28 July 2016

File Number: 2016/401830
Our Ref: R/2016/9/A

State Significant Development 7542 – RPA Hospital Multi-storey Staff Car Park

Figure 1: Shared area located adjacent to accessible car parking spaces

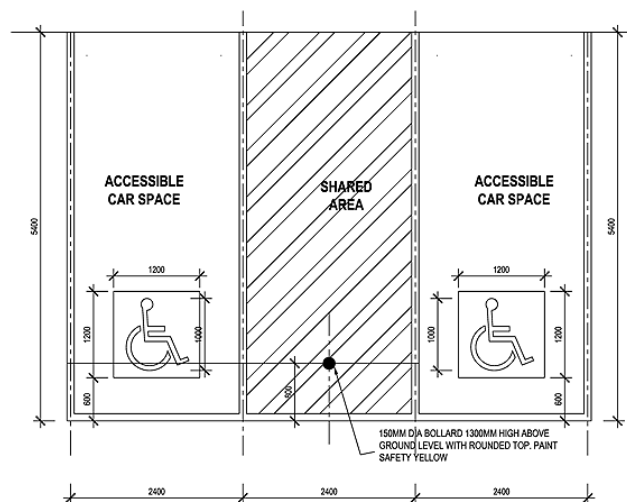
Accessible parking spaces must be designed in accordance with Australian Standards including having the shared area located adjacent to the space (refer to Figure 1 below). It is noted that the plan illustrated in the submitted Traffic Impact Assessment does not comply with this requirement.

The City's Transport and Access Unit recommends that a minimum of 10 accessible car parking spaces be provided in this development, as is currently proposed.

Figure 2: Detailed facade elevation showing the size of the perforations.

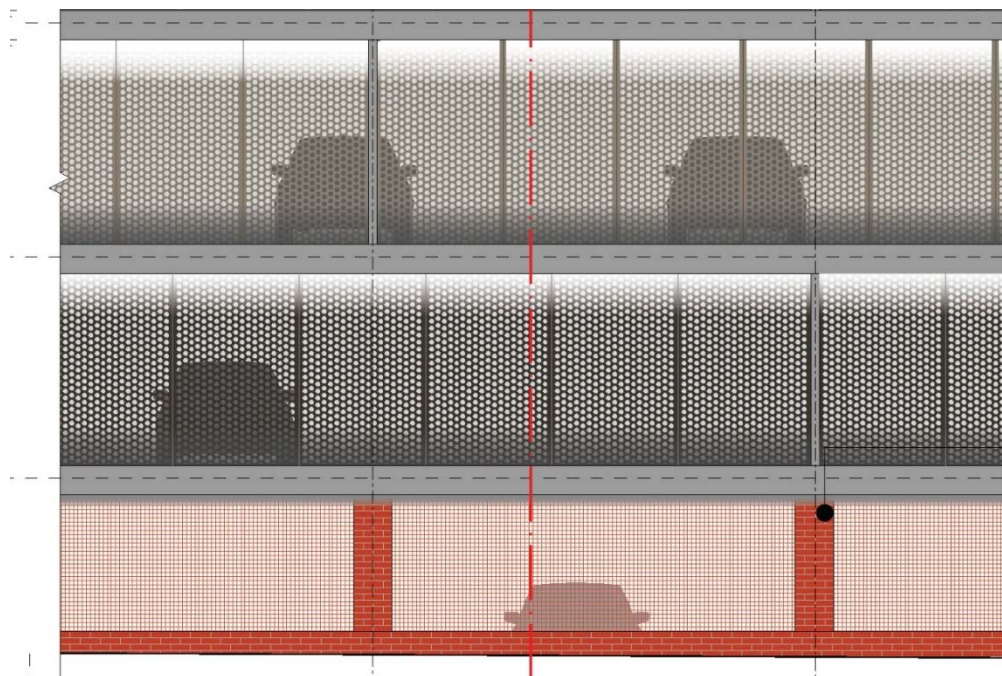
The potential for negative impacts of light spill is not properly addressed in the application. The detail elevation on drawing DA-0204 shows that the perforations may be in the order of 75-100mm in size, despite being labelled as 'small'. This will allow the building to 'glow' at night time, as the scale of perforations does not provide any barrier to light spill.

Currently proposed mitigation measures are limited to the top and bottom of the car park ramps on typical floors. This does not mitigate impacts to the remainder of the facades.

It is recommended that additional mitigation measures be considered to ensure that light spill does not negatively impact the surrounding locality. Measures should also be implemented to prevent headlight beams shining directly into habitable rooms in the Queen Mary Building (QMB).
